Determination 2006/34

Single means of escape from a high-rise apartment building at 47 Wakefield Street, Auckland City

Figure 2: Level 08 Plan, reproduced from AP02 rev -, dated December 2004

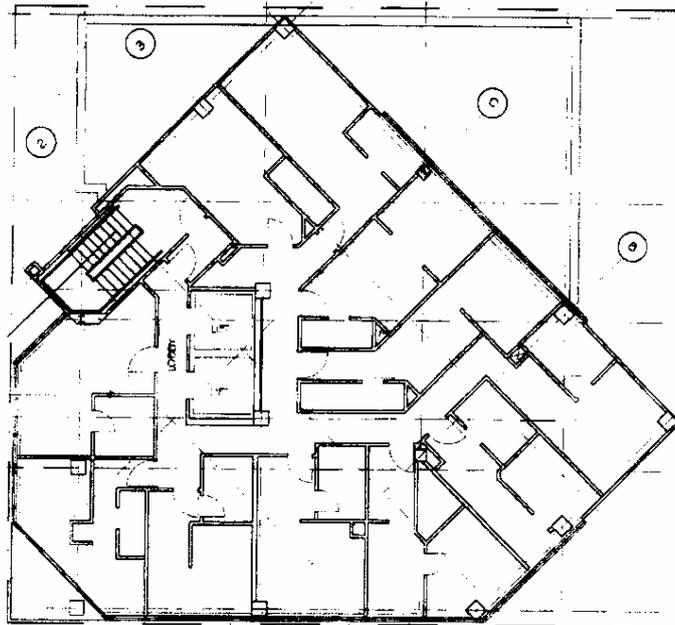
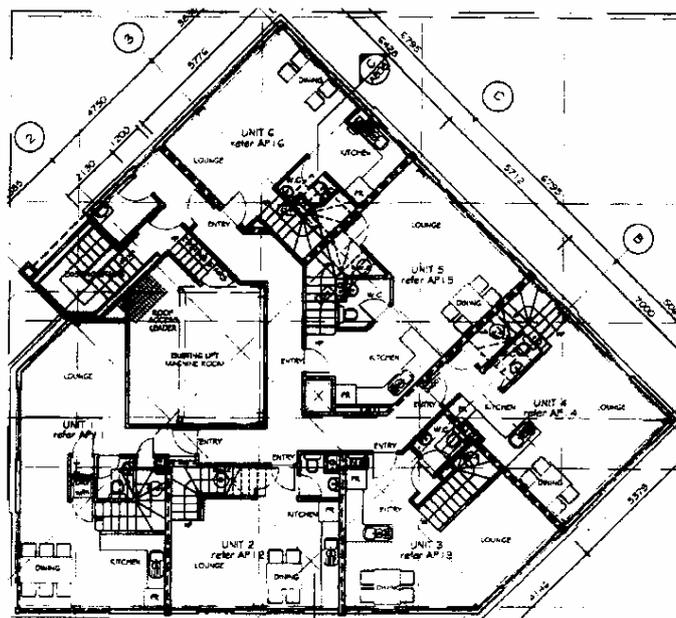
4.3.2 The proposed building therefore differs from one complying with C/AS1 in that:

- (a) It has a single escape route instead of the two required for a sprinklered building with an escape height exceeding 25 m.
- (b) The smoke alarm system within the apartments has been installed to NZS 4514: 2002 which is a lesser standard than that currently expected for a complying Type 5 alarm and indeed is a lesser standard than should have been installed in 2002 if strictly to C/AS1.
- (c) Safe paths are provided, but there is no pressurisation.
- (d) Fire hose reels are provided.
- (e) There is emergency lighting in exitways.
- (f) There is a fire hydrant system.

- (a) as the smoke alarm system referred to in paragraph 4.3.2(c), is an existing system, it may not be "reasonably practicable" to upgrade it.
- (b) the absence of pressurisation referred to in paragraph 4.3.2(d) is of concern.

- The sprinkler system water supply is to be a Class A supply, as defined in NZS 4541 2003, which is a primary tank supply with a secondary town mains supply. Complete and unambiguous plans and specifications are to be supplied to the satisfaction of the territorial authority.

- The stairway pressurisation system is to be designed installed and commissioned in accordance with the Standard AS 1668.1:1998. Plans and specifications are to be supplied to the satisfaction of the territorial authority.

- The fire engineer is to monitor construction to a level and frequency agreed with the territorial authority and provide a "Producer Statement of Construction Review" to the satisfaction of the territorial authority on completion.

- Doors are not to be locked from the stairwell side in a manner that would prevent occupants from being able to enter any floor level from the stairwell in fire alarm conditions.

Fig. 4. Risk comparison of Building C and Building A.

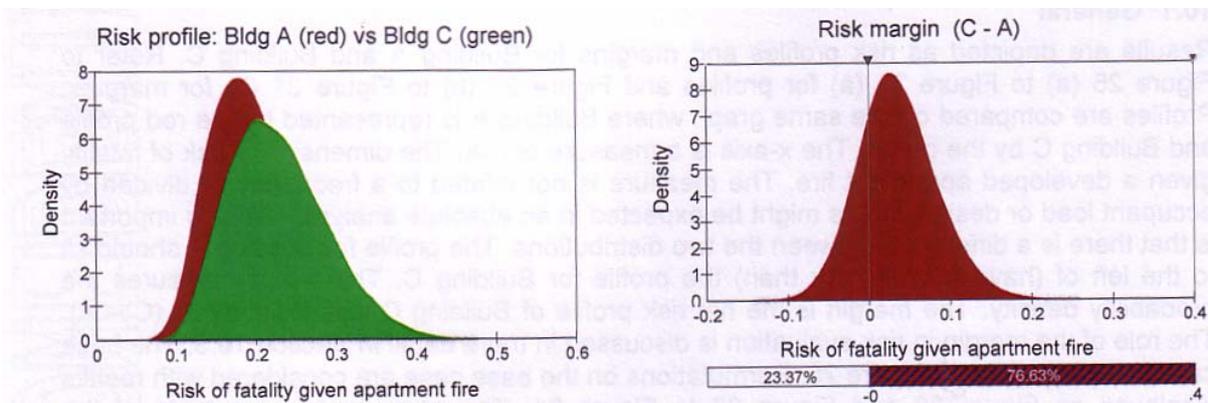
5.9.1.4 The graphs are generated from the outputs from the @RISK computer programme. The risk profiles of the two buildings from the @RISK computer analysis are overlaid on each other to show the risk profiles of the buildings in relation to each other. This shows the risk profile for the proposed building (Building A) sitting to the left of the corresponding profile of the control building (Building C), and indicates that Building A has a lower risk in the event of fire. The second graph shows the risk margin, and is the net risk profile of Building C minus the net risk profile of Building A. The result shows that there is a margin of 77% in the base case.

5.9.1.5 The experts noted that two comparable or equivalent buildings will have a margin of 50%. The possibility that things will go randomly wrong in Building A compared with things going right in Building C will mean that the comparison will have a distribution even if they were designed exactly the same. However, in addition to random variability in the input parameters, there is also uncertainty and this may lead to error. To compensate for this uncertainty, a margin of greater than 50% is sought.

5.9.1.6 The experts point out that in Determination 2005/109, 74% for the base case was not considered high enough. The corresponding margin for Building A in the current analysis is 77% (for the base case), which is above the upper limit of Determination 2005/109. It should be noted that these values are not directly comparable. Determination 2005/109 did not consider time-dependent effects, and if it had, it is the experts' opinion that the margin would have been lower, meaning that the difference between the margins in the two buildings (that in Determination 109 and this building) is greater.
